## **ABBREVIATED PLAT AGENDA**

**STAFF REVIEW AND RECOMMENDATIONS  
PUBLIC HEARING  
May 31, 2023**

**ABBREVIATED PLAT:** RIPJENSON

**REVIEWED BY:** MATTHEW GODDARD      **CASE #:** 2023-050

A PLAT OF  
RIPJENSON SUBDIVISION

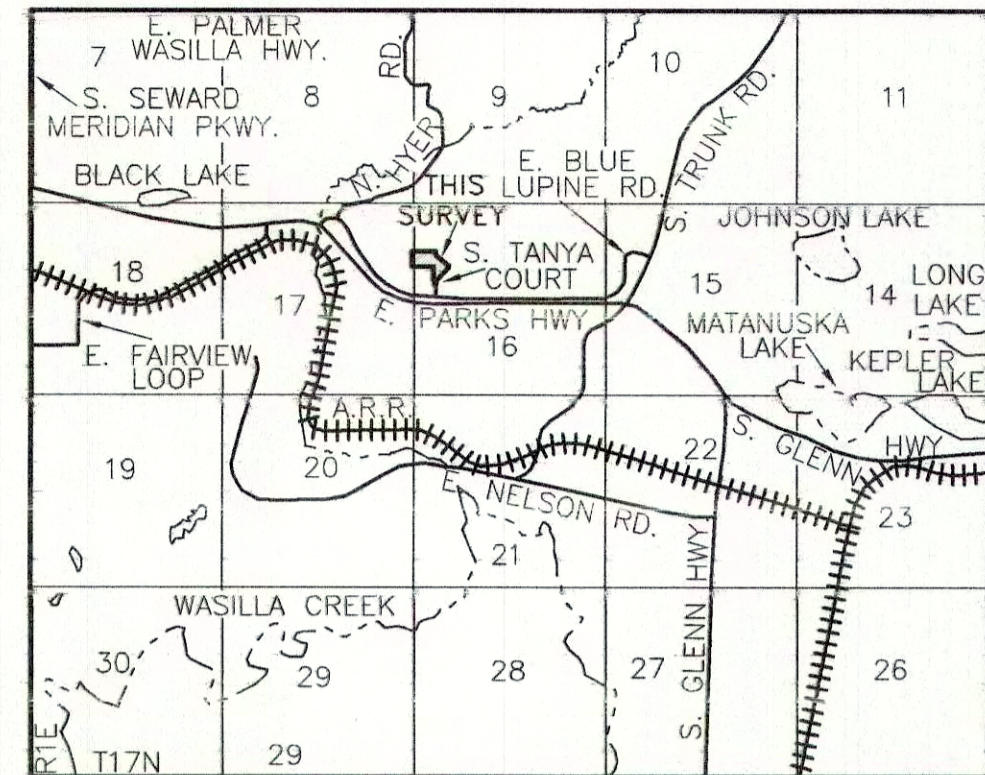
For years, as both an RSA and FSA board member I've fiercely despised and rejected any and all 'flag lot' platting for numerous practical and very real reasons of conflict avoidance. The rewrite of Title 43 to alter them even to what is allowed now is still not to my liking.

After living within the 'wind tunnel' that effects this general area, it also does not escape me that prevailing winds in this particular vicinity are south-westerly in direction and will naturally force any snow that is not moved to the northeast will cascade down the steep bank and encroach on the adjoining property owner on Lot 1. It will literally mandate a situation that will require the snow be plowed in the most unfavorable direction, with the obvious effects. This simply defies justification.

While both lots in this proposed replat happen to be owned and controlled by the same owner, it does not alter the fact that there is potential for the current and convenient 'seamless line' between them, eliminating unrestricted snow removal toward the northeast from the 'driveway (as plotted)', to become restricted.

Further, there is opportunity for the present owner of both lots to sell either lot, setting the stage for a clearly restricted and conflicted snow removal problem.

Likewise, natural erosion and gravity will tend to allow the steep embankment on the Lot 1 edge of the driveway of Lot 2A to slide downhill, narrowing the driveway/access for the rest of Lot 2A, possibly even to the degree of insufficient width to allow passage from Tanya Ct. to the bulk of the property. This would be unacceptable under all circumstances.

I would propose, if any changes to accommodate the stated problem are made that a 'land trade' be made. Replat the proposed 'leg' or 'flagpole driveway' of Lot 2 to Jensen Lot 9A and replat the lot line between Jensen lots 8 and 9 to be the driveway for access into Lot 2 (or 2A, as shown on the replat).
